**RE: 142 40<sup>th</sup> St. SW**  
**Grading and Drainage Plan**  
**Engineer's Stamp Date: 10/05/23**  
**Hydrology File: K12D037**

**RE: 142 40<sup>th</sup> St. SW**  
**Grading and Drainage Plan**  
**Engineer's Stamp Date: 09/05/23**  
**Hydrology File: K12D037**

ENGINEER'S SEAL <b>DAVID SOULE</b> NEW MEXICO 14522 REGISTERED PROFESSIONAL ENGINEER	<b>LOT 6, Blk 2 New Bridge Acres Add</b> <b>142 40TH STREET</b>	DRAWN BY <b>DEM</b>
10/5/23	<b>GRADING AND DRAINAGE PLAN</b>	DATE 11-5-22
DAVID SOULE P.E. #14522	<b>Rio Grande Engineering</b> P.O. BOX 53924 ALBUQUERQUE, NM 87199 (505) 321-8099	LOT 6, Blk 2 New Bridge Acres Add, DWG
		SHEET # <b>C1</b>
		JOB #

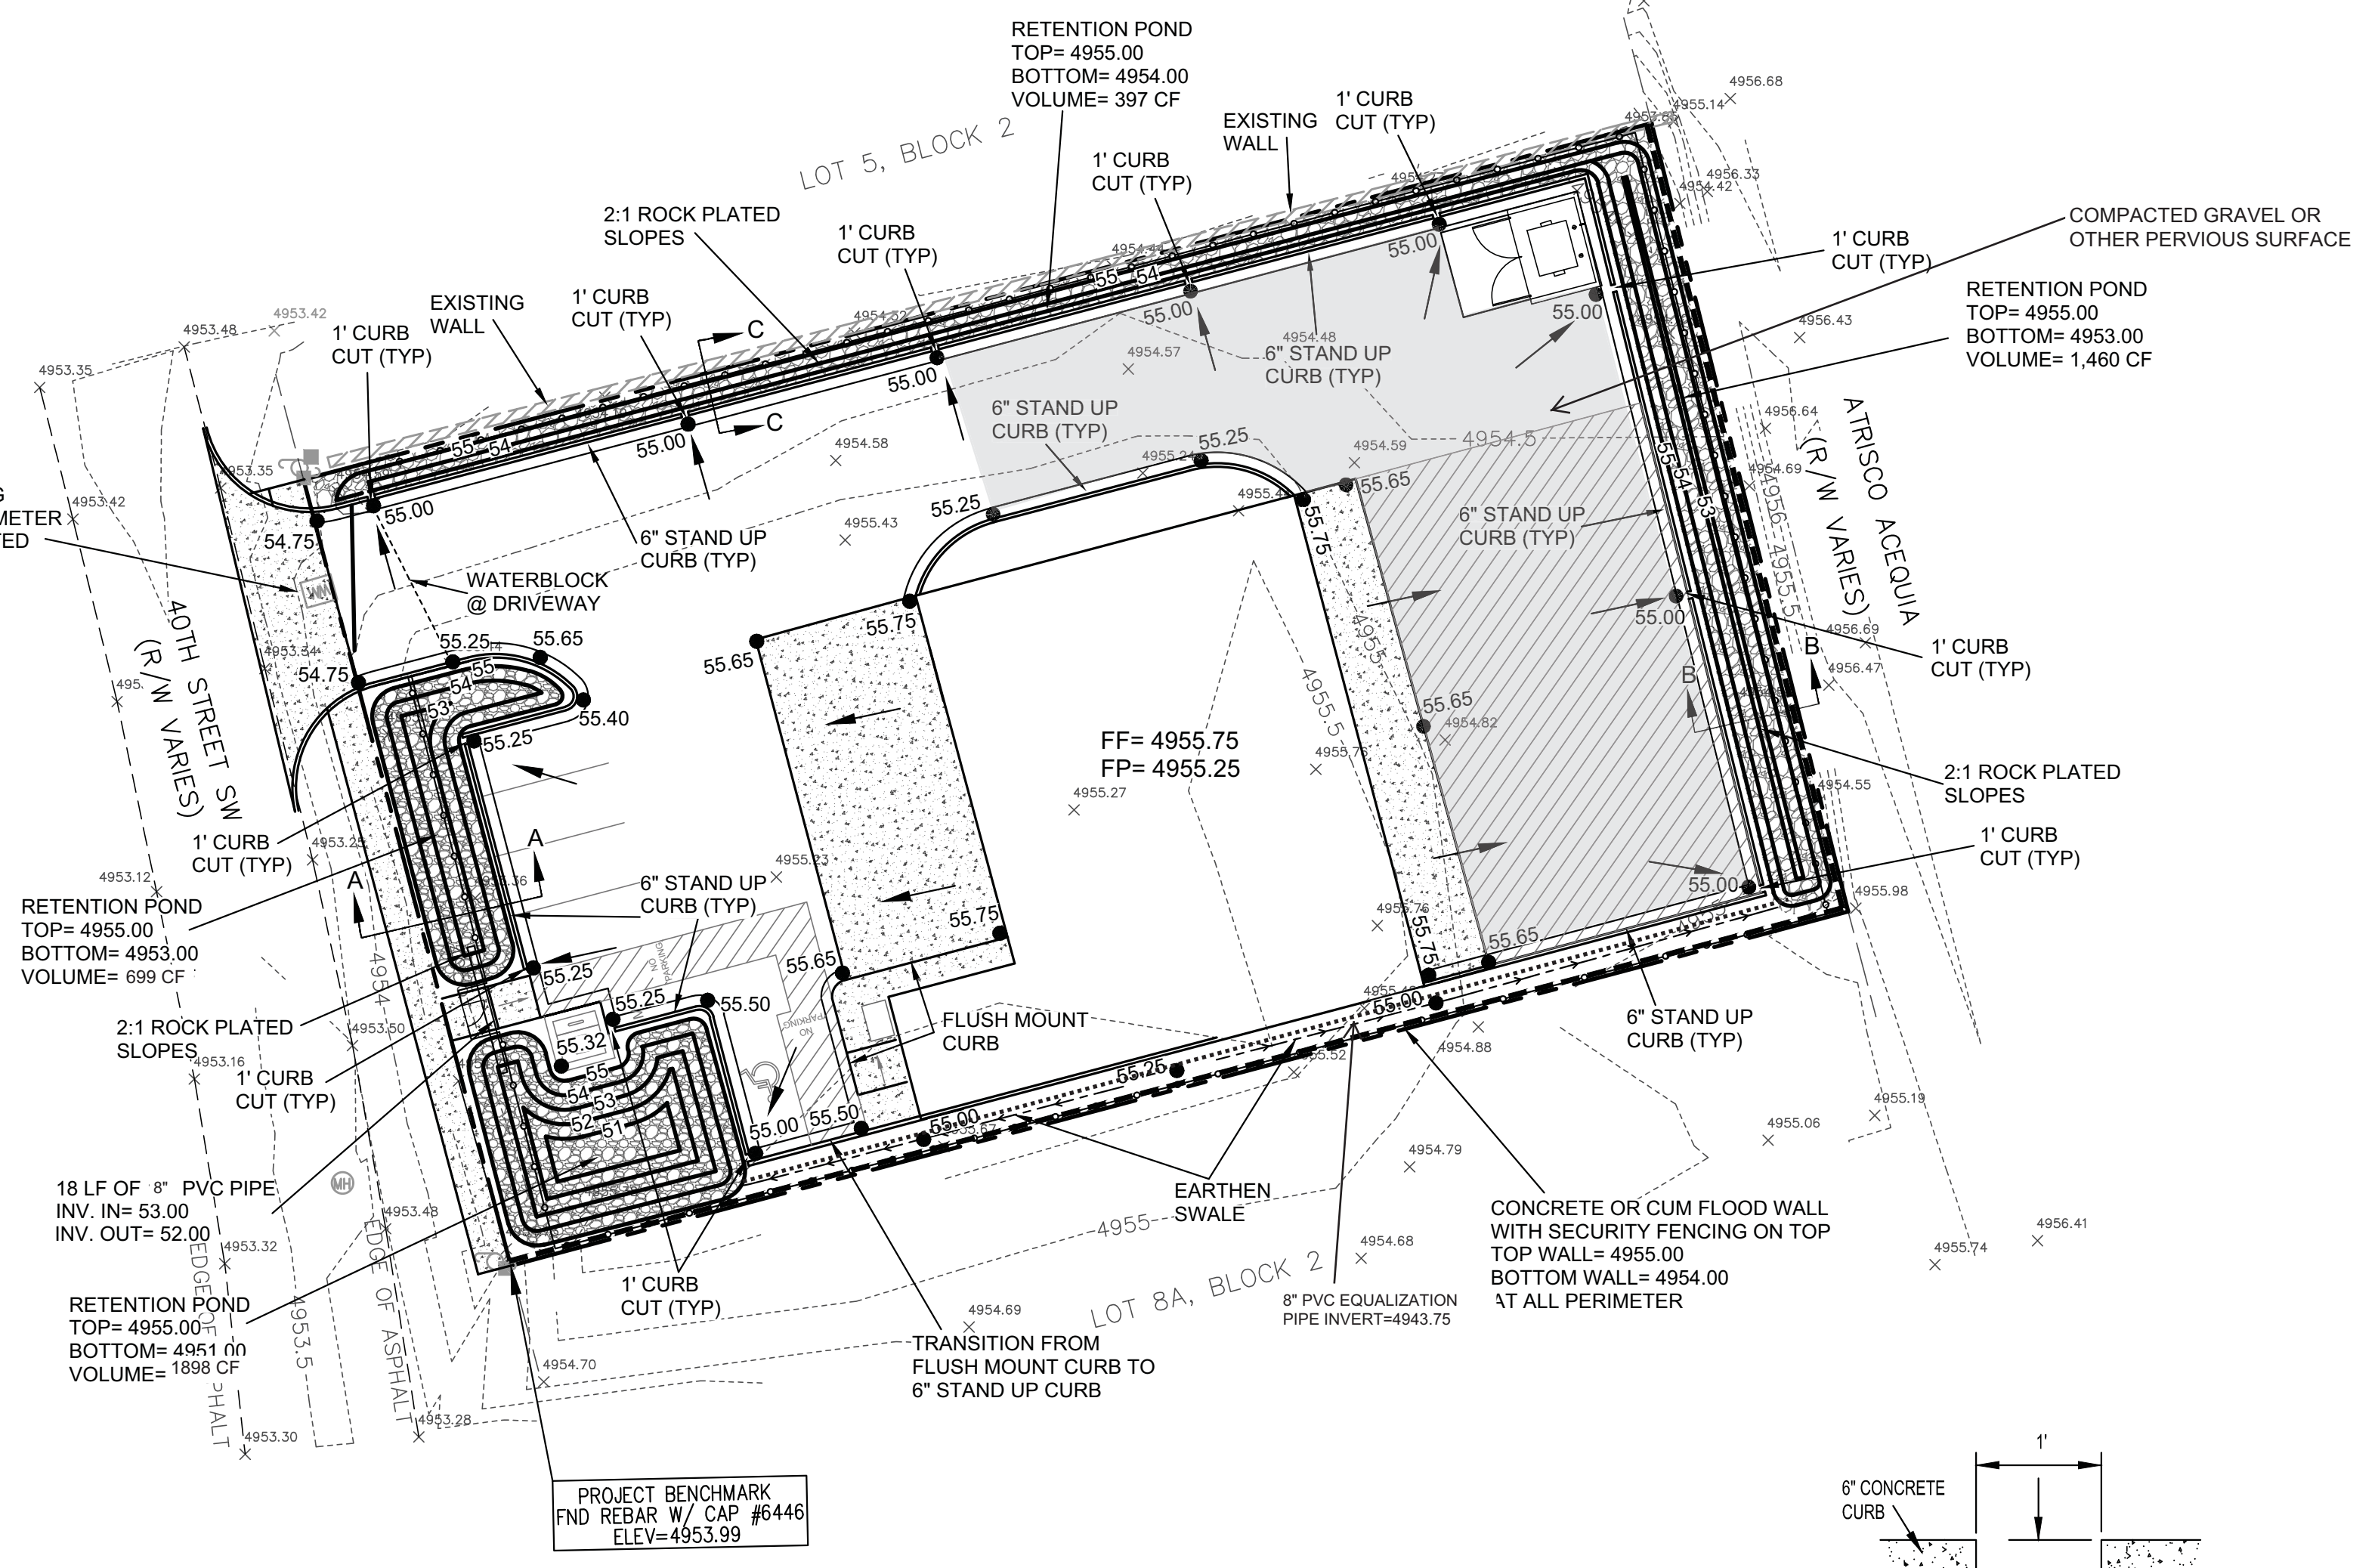
1. Please provide the stormwater quality calculation, multiply the impervious area by 0.26 inches for redevelopment sites. **CORRECTED**
2. please follow Article 6-5 Valley Drainage Criteria of the DPM. The following conditions must be applied to the site:

- a. The maximum percent impervious of the lot and the contributing area may not be greater than 45%. **REDUCED TO 44% BY REPLACING REAR WITH GRAVEL**

- b. Pad elevation shall be a minimum of one (1) foot above the 100 year 10-day stormwater surface elevation. **THIS IS COMMERCIAL, THE ADA PREVENTS US FROM RAISING PAD. THE LOT OVERFLOWS TO SURROUNDING AREA. THIS FUNCTIONS IN ACCORDANCE TO THE STANDARD**

- c. The flow between the front yard and back yard cannot be obstructed. The stormwater must be allowed to equalize to the same level between the front yard and back yard. **PROVIDED**

- d. A permanent perimeter wall or barrier around the development is required to contain the 100 year 24 hour storm developed runoff. **WALL DETAILS SHOW**

- e. The high point of the street should be four inches above the 100 year 10-day stormwater surface elevation. **THE SITE IS EXISTING AND HIGHER THAN THE SURROUNDING AREA**

- f. The retention pond is the 100 year 10-day volume and not the 100 year 24 hour volume. **CORRECTED**

This site is an redevelopment of a previously developed lot. The site is in general conformance to the valley flat area drainage scheme. Due to existing grades and ADA requirements we are not able to provide roads higher than the 10-day volume nor pad 1' higher. The site will retain the entire 100-year 10-day volume. The ponds will overflow to the street in the event of a storm exceeding the 100-year event. The surrounding are is flat and lower than site offsite flows are not allowed to enter the site. The first flush volume is retained on site.
